Architect's Supplemental Instructions

Architect's ASI No: 051

Project:
Webster University
Interdisciplinary Science
Building

ASI-051 is being issue for the purpose of providing a mechanical equipment condensate drain connection to the plumbing waste system.

3-4 SANITARY WASTE AND VENT RISER - LAB 480 AND LAB 488

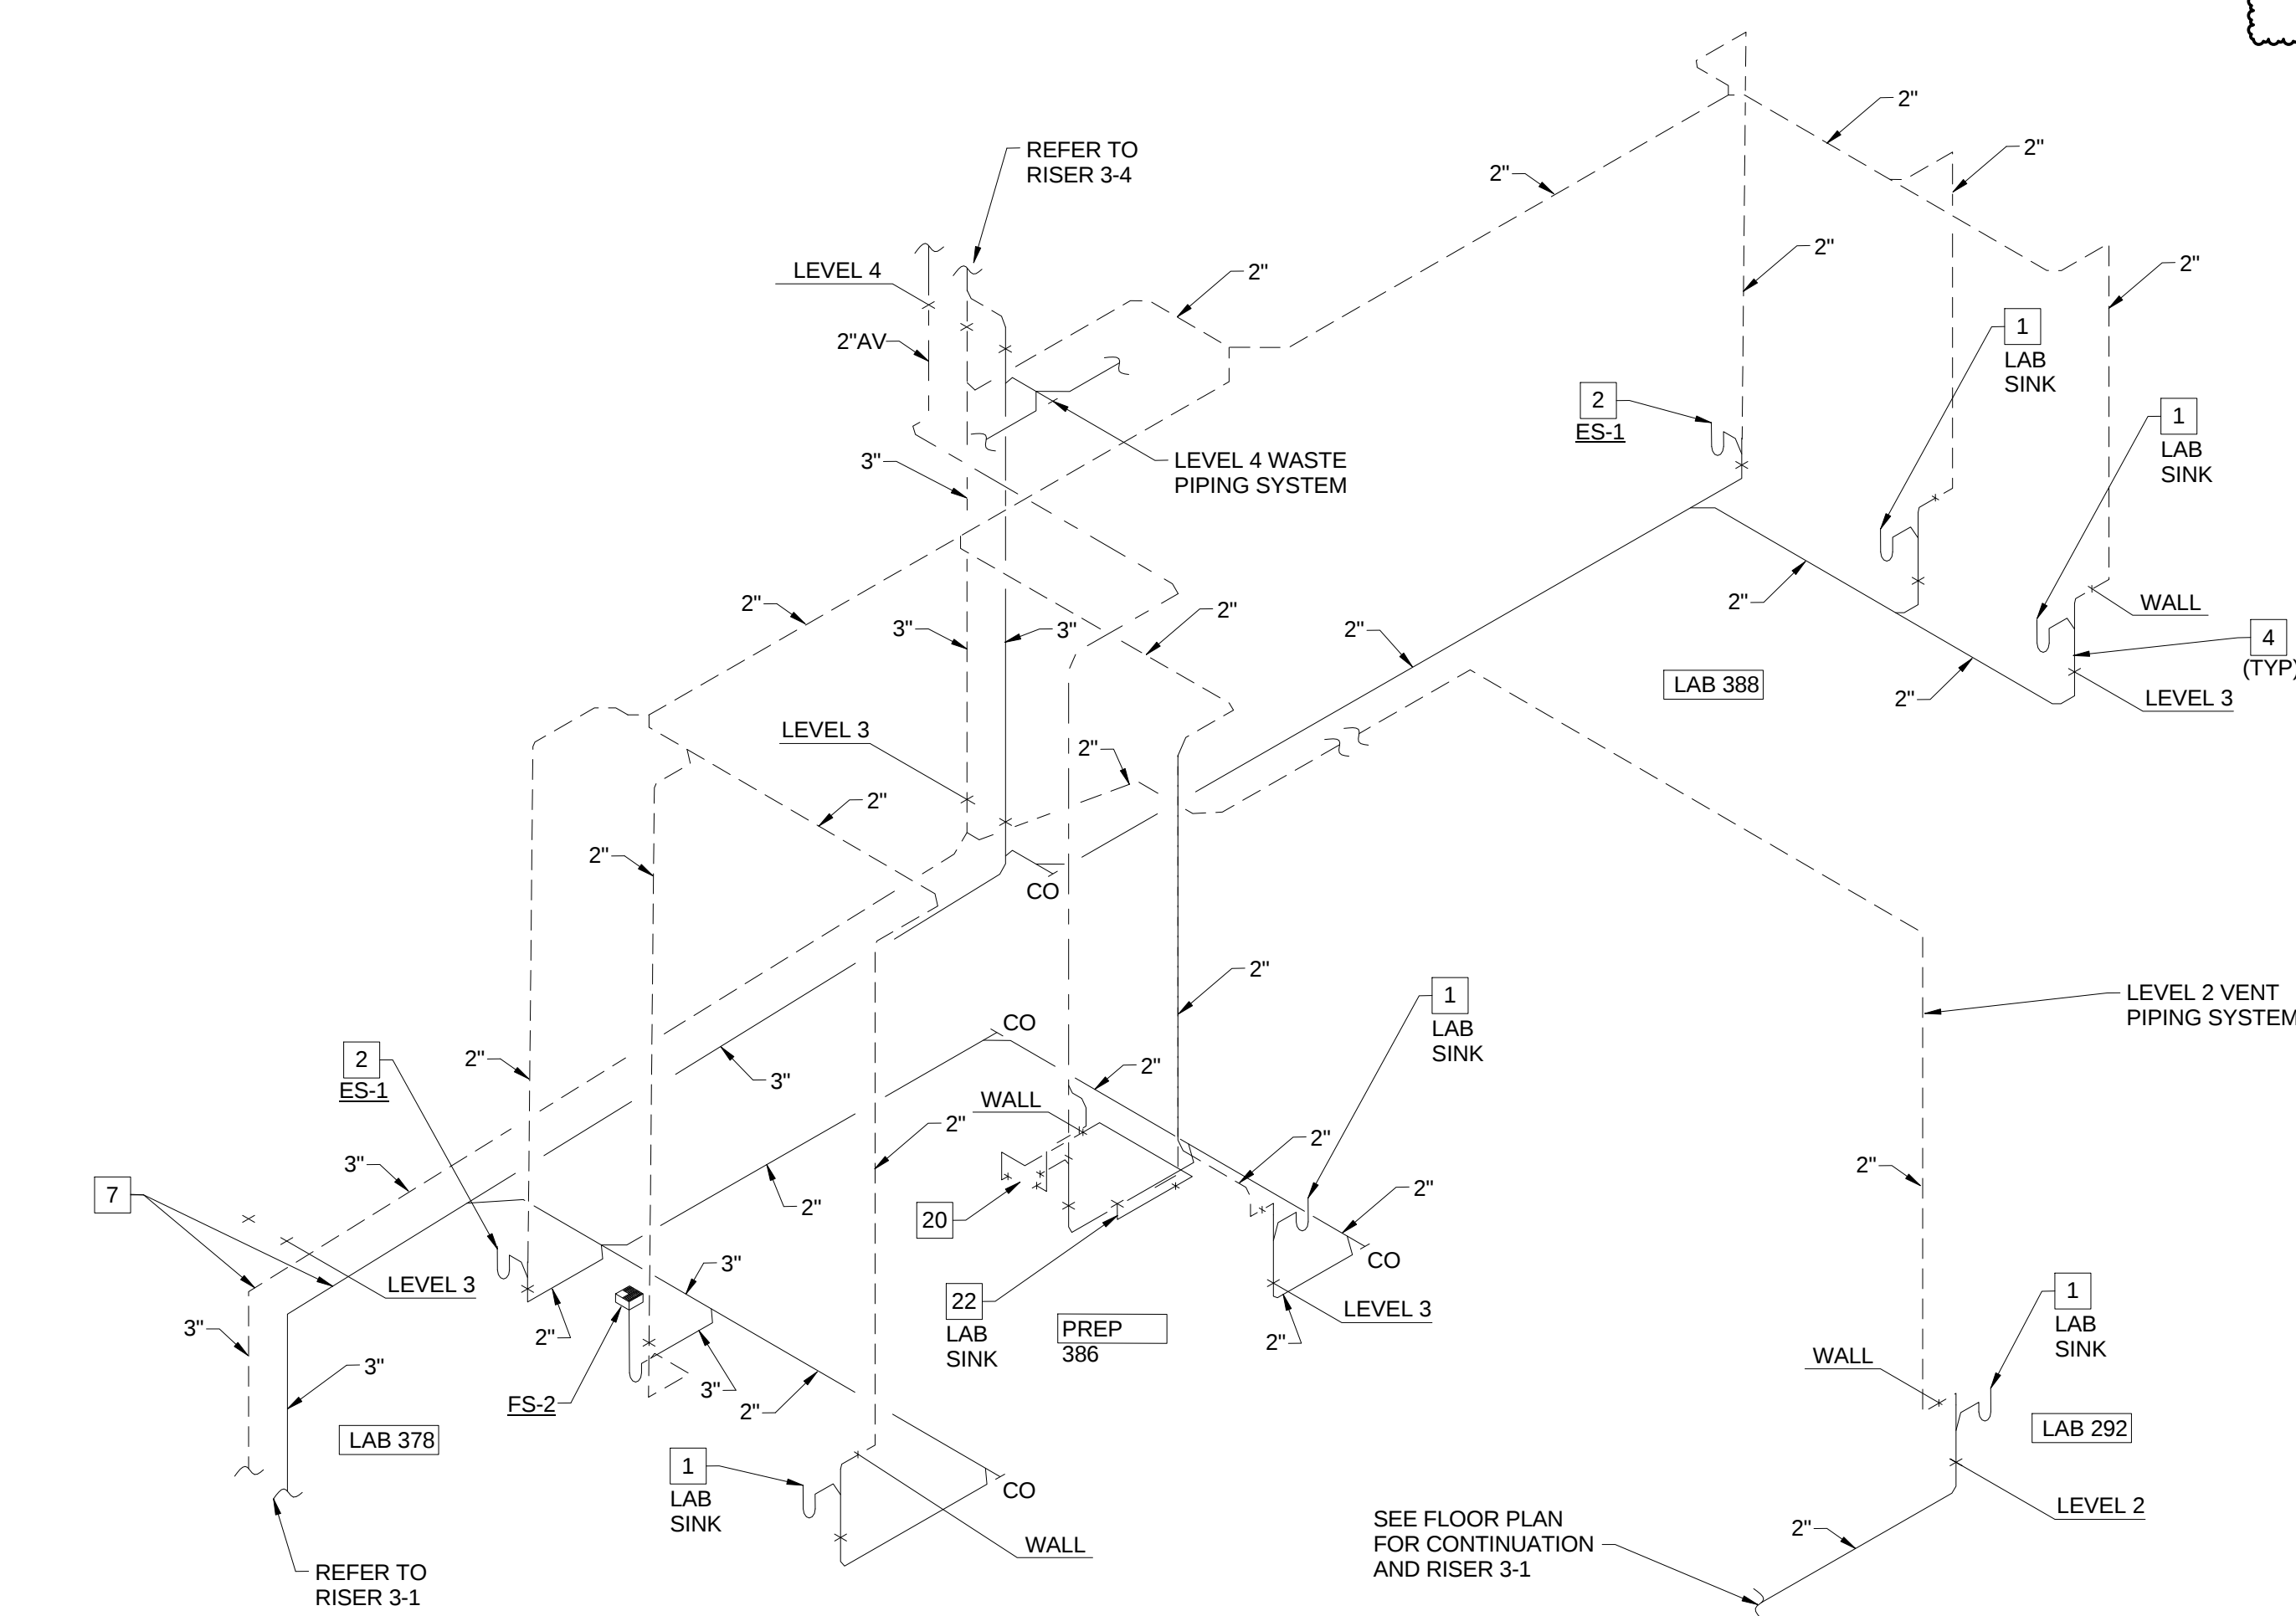
SHEET P0406 – RISERS PLUMBING

- Modified riser 3-4, added key note 25.

- 25 3/4" CONNECTION FOR CONDENSATE DRAIN SIMILAR TO THE FITTING USED FOR THE GLASS WASHER CONNECTION. COORDINATE WITH THE MECHANICAL CONTRACTOR FOR THE EXACT REQUIREMENTS.
